Re: Permanente Quarry, Mine ID # 91-43-0004
Application for Reclamation Plan Amendment (PLN 19-0106)
Response to July 22, 2019 Incompleteness Determination

Reference: Responses to SCC Incompleteness Determination for Permanente Quarry

Reference: Permanente Quarry – WMSA Slope Instability Remediation Plan

Title
North Highwall Reserve
Cross-Section

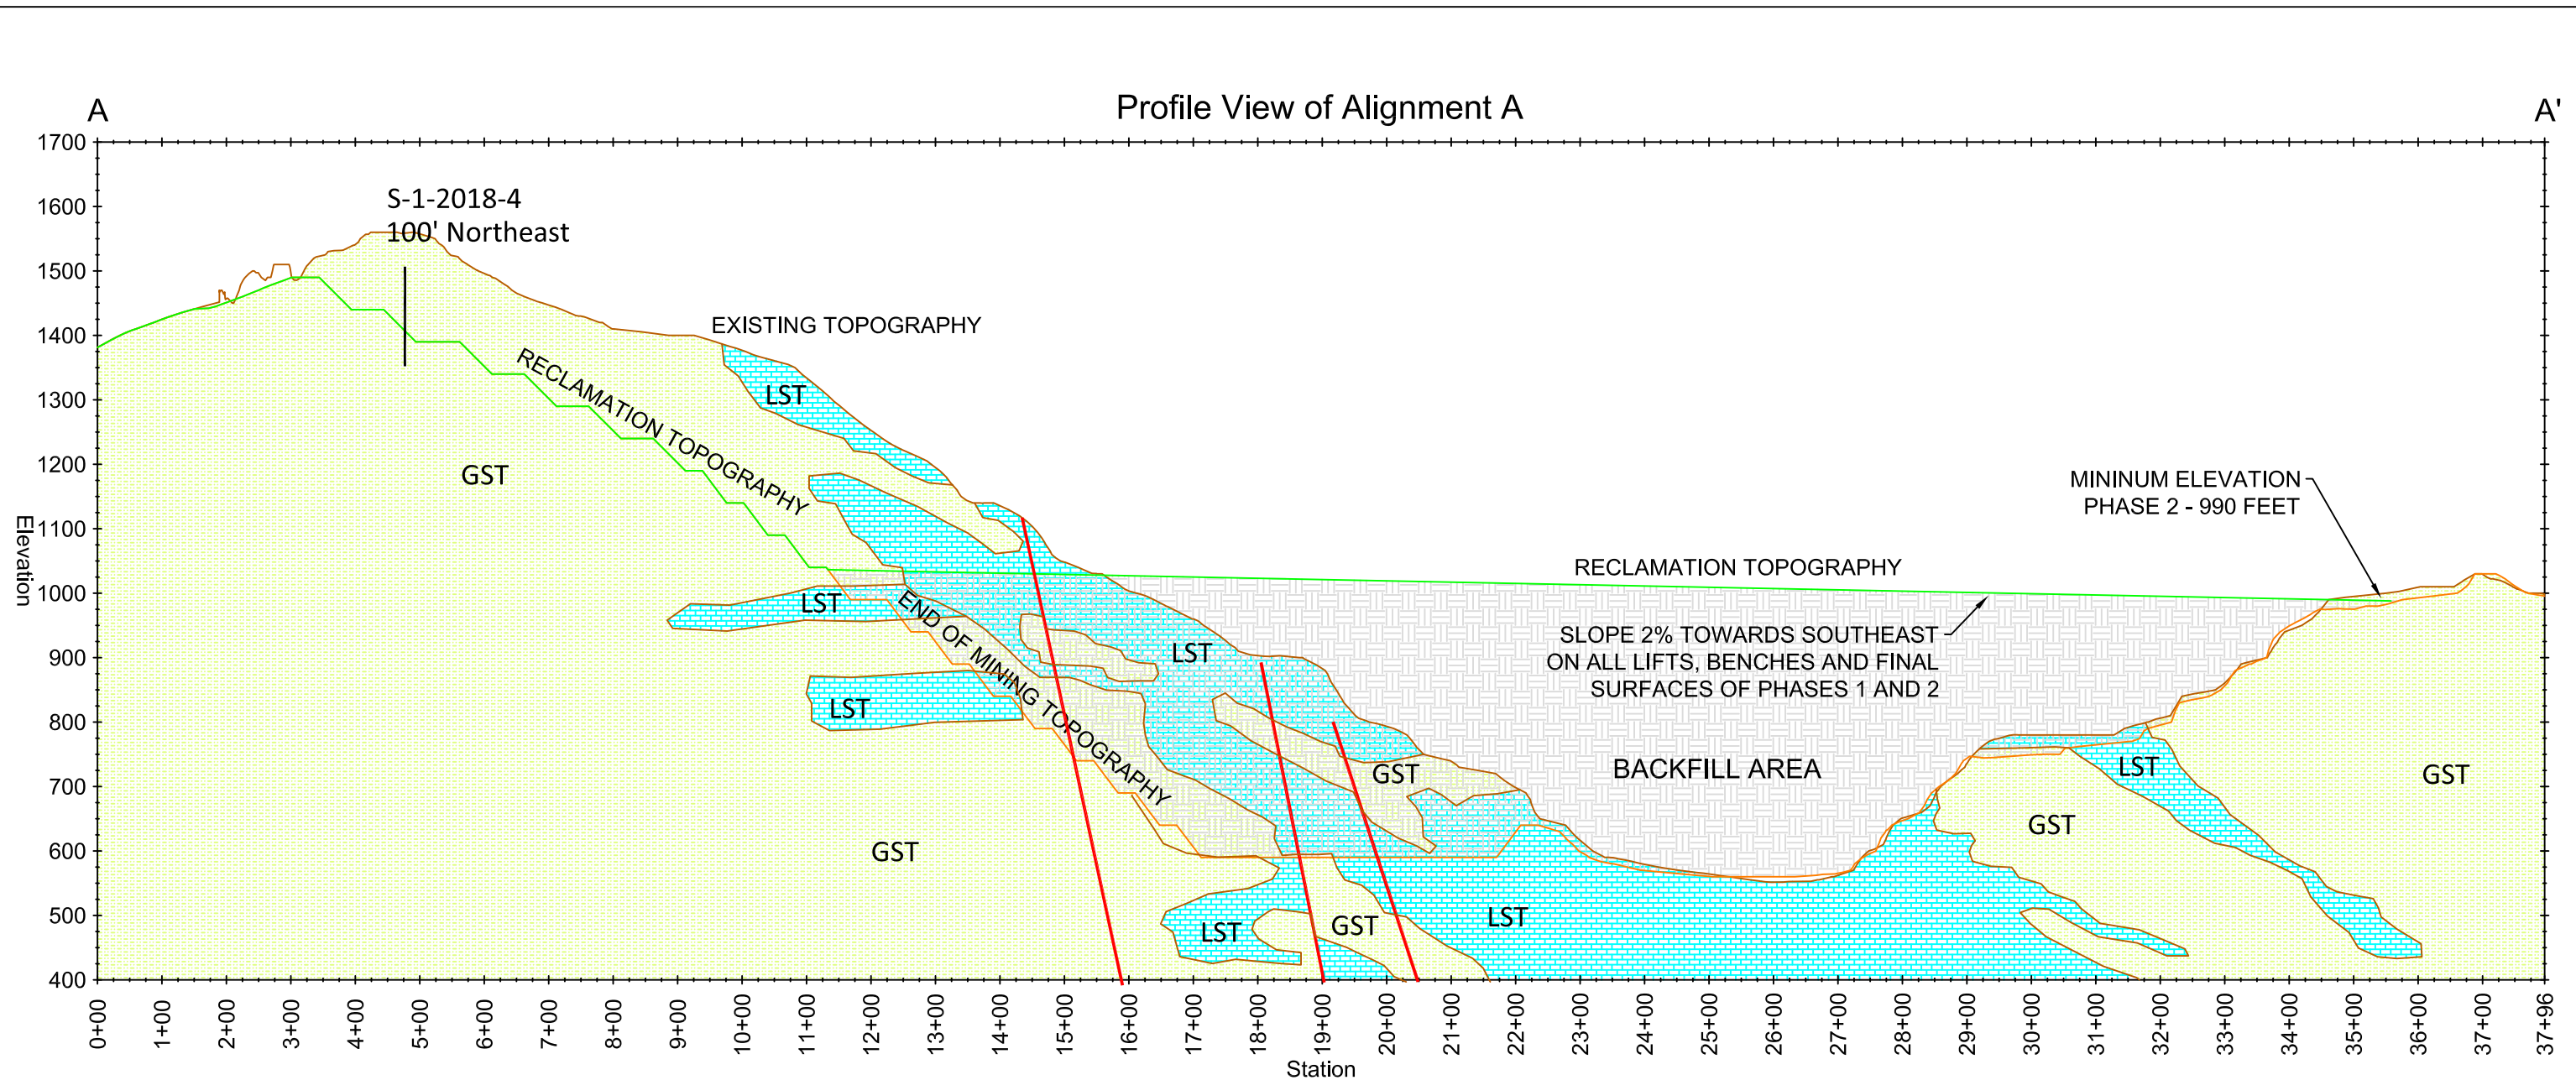
2. *Subsurface geologic interpretations (fault planes, bedding planes, etc.) need to be added to all of the cross-sections (e.g. Figure 3.3 in Binder 1, Appendix G) and the “models” used in the slope stability analysis (including the additional cross-sections and analyses referred to in the following comments #3 and #4).*

- North Highwall Reserve Figures 3.4 a, b, and c Cross-Sections
- North Quarry Backfill Figure 2.4 Cross-Section
- West Material Storage Area Figure 2.5 Cross-Sections
- Rock Plant Reserve Figures 3.4 Cross-Sections

Client/Project
Lehigh Southwest Cement Company
Permanente Quarry
Figure No.
2.5
Title
West Material Storage Area
Cross-Sections

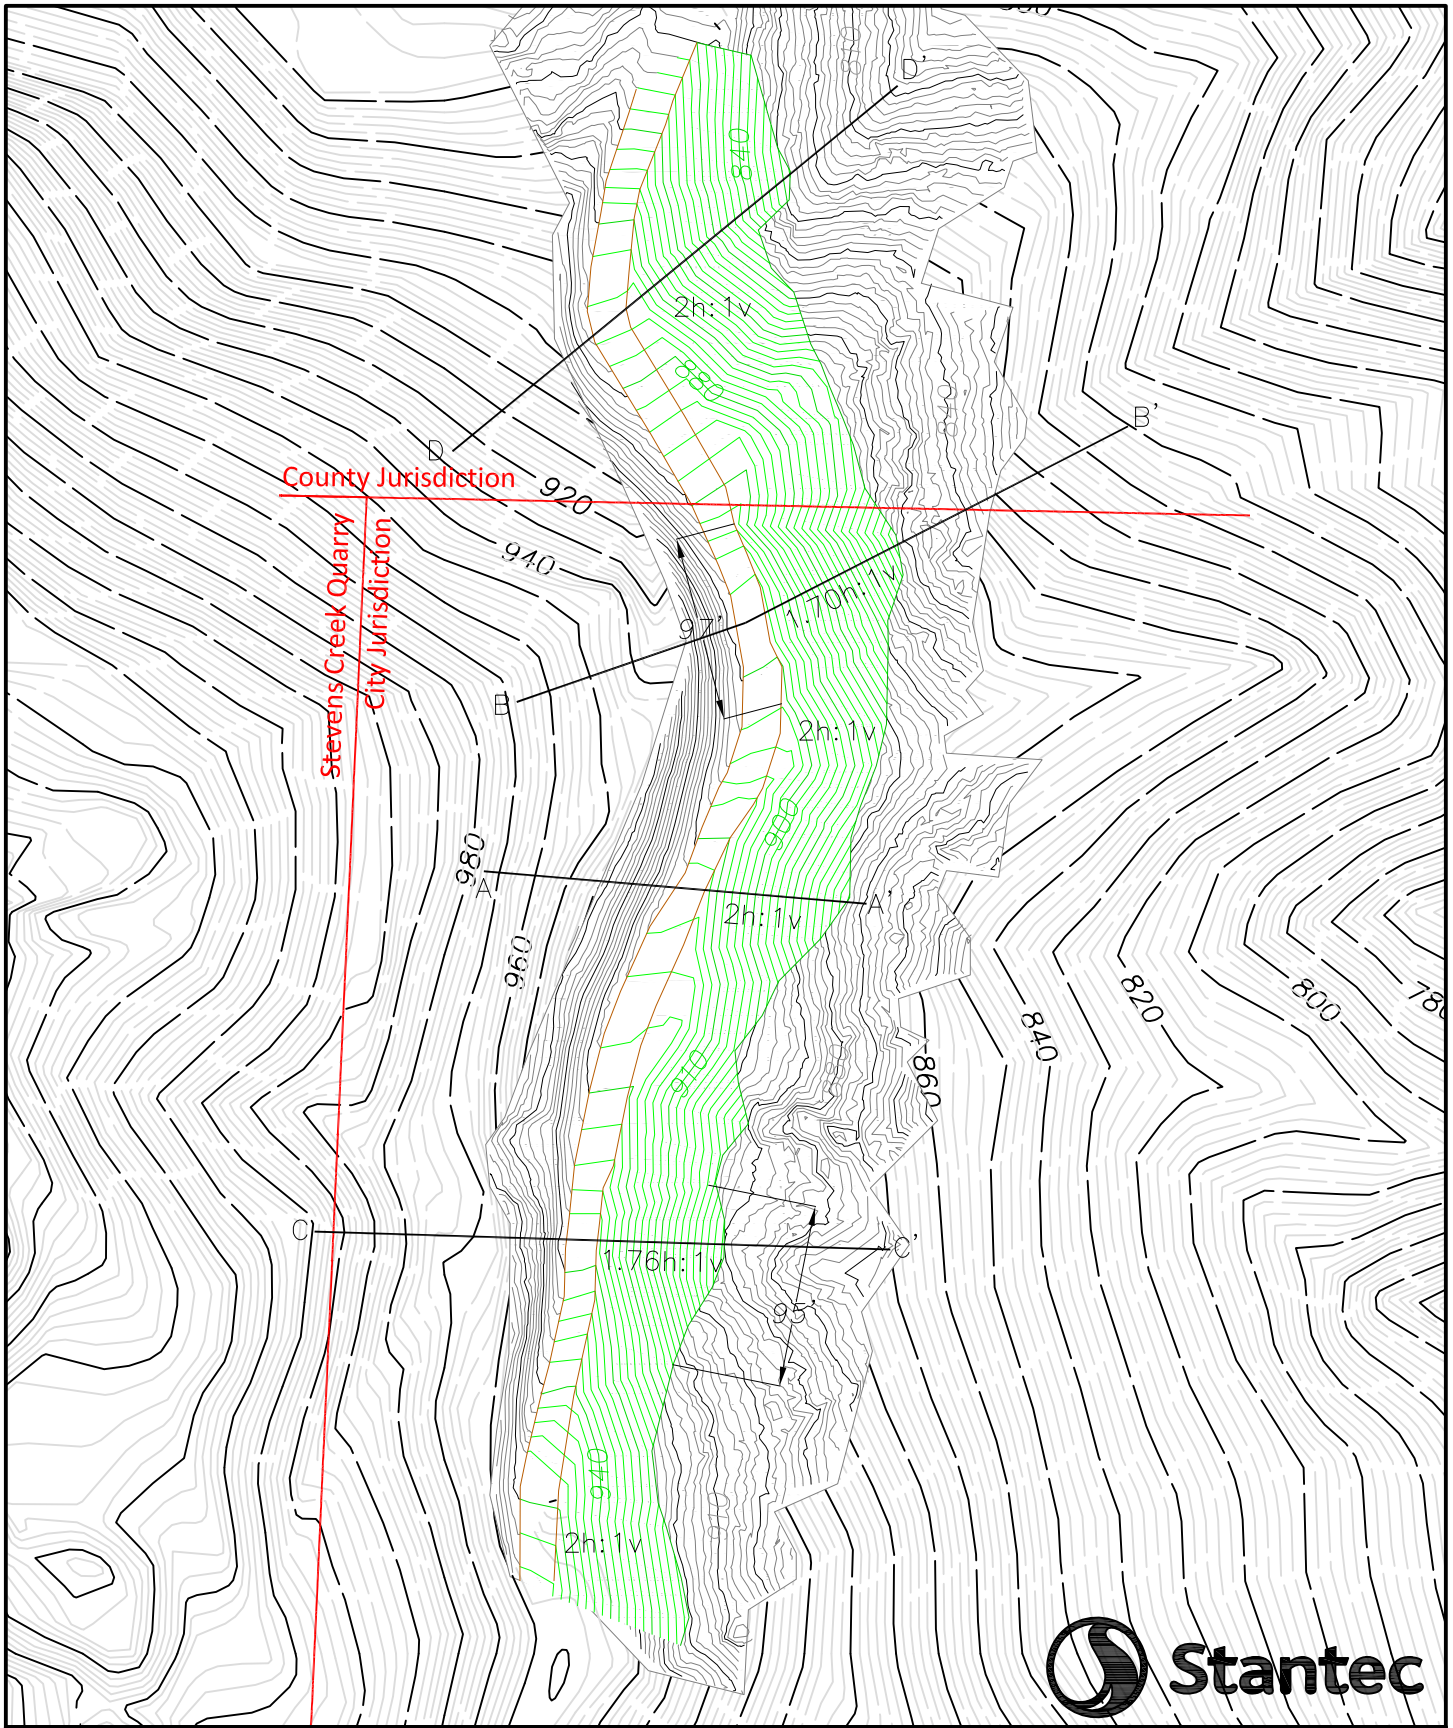
3. *An additional cross-section and related slope stability analysis are needed for the south-facing slope in the Yeager Yard Area, including the area containing Well WMSA-DMW-11 located at the south end of the WMSA. Additional surface mapping and subsurface exploration are needed to thoroughly evaluate the extent of ground movement that appears to have occurred in response to the removal of a substantial amount of material from the lower portion of the slope.*

Utility Road Grading Plan

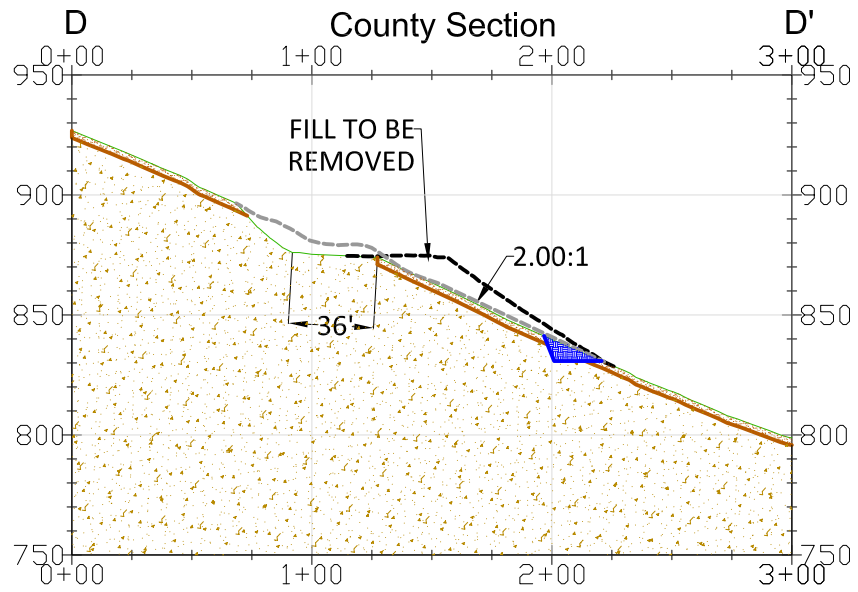
4. *An additional cross-section and related slope stability analysis are needed for the east-facing cut and fill slopes located north of the “County Jurisdiction” line in Figure No. 1 “Utility Road Grading Plan” in Appendix G-5.*

Stantec has prepared a cross-section (D-D') of the Utility Road that is located in County Jurisdiction. The section location is shown on revised Drawing 1, and the cross-section is included on Drawing 3.
